SKETCH 1

RE: Dr. Daniela Eversgerd
Dental Office
1901 Highway 190, Suite 13
Mandeville, LA 70448
Job # 588-16

I have reviewed the proposed layout of the slab removal as shown on Sheet 0101 by Dammon Engineering, Inc.

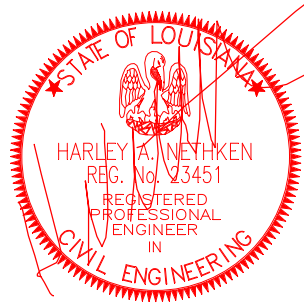
#3 x16" DOWEL BARS
 @ 36" O.C. STAGGERED
 EPOXY SET 4"-6"

FULL DEPTH
 SAW CUT

6x6x 6/6 MESH

UNDERPIN

UNDERPIN
